Federal Aviation Administration – [Regulations and Policies](#)  
Aviation Rulemaking Advisory Committee

Transport Airplane and Engine Issue Area  
Loads and Dynamics Harmonization Working Group  
Task 20 – Ground Handling Conditions

Aviation Rulemaking Advisory Committee Transport Airplanes and  
Engine Issues--New Tasks

FIGURE 9 – Convex Runway Profile

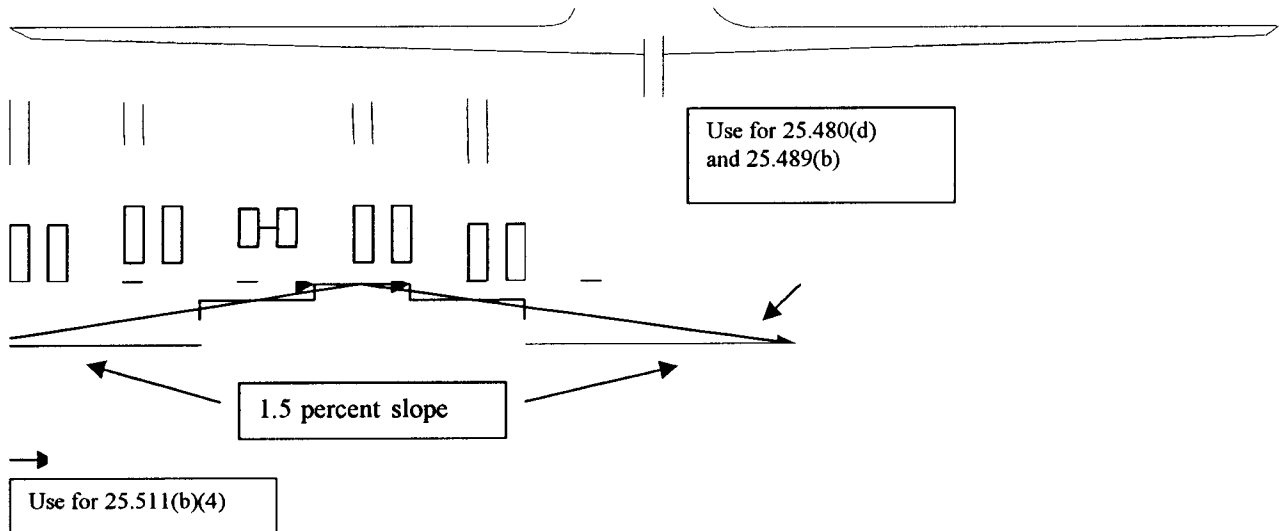
(d) For airplanes with two main landing gear units, landing is considered on a level runway. For airplanes with more than two main landing gear units, landing must be considered on a level runway and, as a separate condition, on a runway having a convex upward shape that may be approximated by a slope of 1.5% at main landing gear stations, as shown in Figure 9 of Appendix A.

- For airplanes with more than two main landing gear units, a convex runway shape must be considered. A new figure (Figure 9) is added to Appendix A to depict this runway profile, and is also

referenced by Secs. 25.489 and 25.511. This figure is shown on the last page of this document.

- Paragraph (a) is reorganized for clarity.
- “No wing lift may be considered” is changed to “The airplane lift must be assumed to be zero” for clarity.
- Paragraph (b) is added to address airplanes with more than two main landing gear units. For these airplanes, a convex runway shape must be considered. A new figure (Figure 9) is added to Appendix A to depict this runway profile.
